INDEPENDENT ADVISORY PANEL FOR UNDERGROUND MINING

ADVICE RE:

**TAHMOOR SOUTH
LONGWALLS S1A – S6A
EXTRACTION PLAN**

August 2022

Figure 2. Mine plan showing heritage sites (source: Tahmoor presentation on 19.07.22)

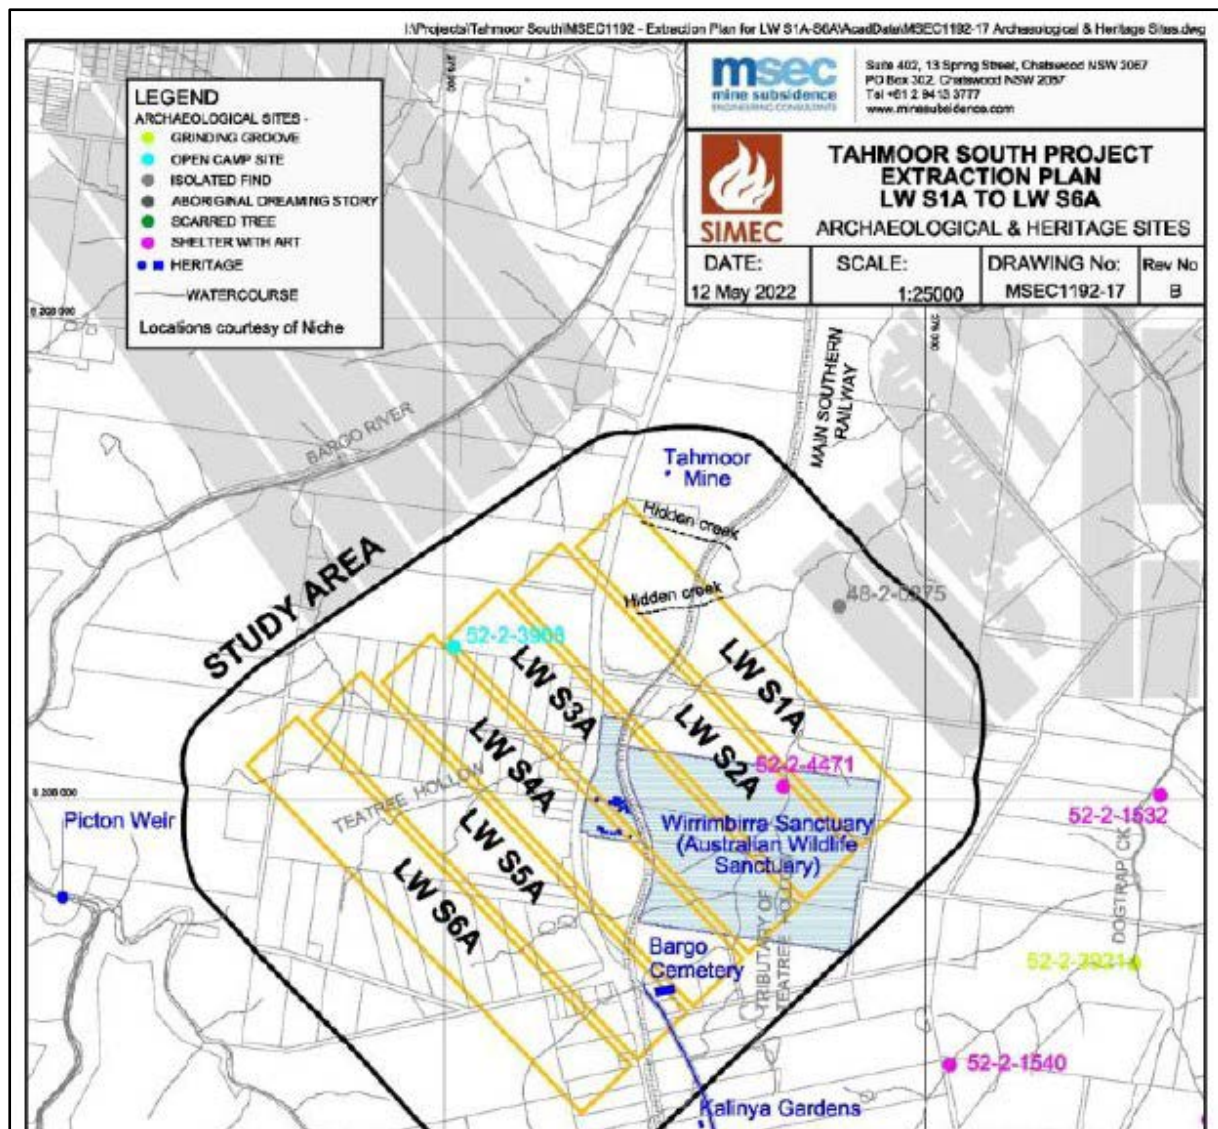
The location of this heritage site relative to the proposed mine plan is shown in Figure 2. The site location is marked on the boundary between LWS1A and S2A, marked as site 52-2-4471.

It is understood that this rock shelter is one of 19 across the entire Tahmoor South Domain but is the only one above the “A” group of longwalls, LWS1A to S6A. Under the terms of the Development Consent, mining should not impact more than 10% of the total number of rock shelters across the whole Tahmoor South Domain, i.e. less than 2 shelters in total are permitted to suffer mining-induced impacts (such as cracking, rock falls, toppling etc) across the entire Tahmoor South Domain.

Given the location of this shelter above the panel edge of LWS2A, it will clearly be subject to subsidence effects including vertical subsidence, tilt and tensile strain – all of which have the potential to induce adverse impacts such as those noted above. Such impacts would then result in potential damage and/or loss of the rock shelter. Under the Development Consent conditions, this would then account for the 10% limit of impact to the total of 19 rock shelters, meaning that no further rock shelter impact would be permitted across the subsequent longwall B panels further to the south. The nature, quality and locations of the other 18 rock shelters is not known by the Panel.

It is recommended that subsidence impact mitigation measures be considered, and a mitigation plan developed for implementation in conjunction with the rock shelter above the boundary between LWS1A and LWS2A in order to minimise the risk of adverse impacts to this rock shelter.

The above recommended mitigation plan should be developed in conjunction with and informed by a broader assessment of the relative merits and value of all of the 19 rock shelters, in order to prioritise which 18 of these 19 (as a minimum) need to be protected.
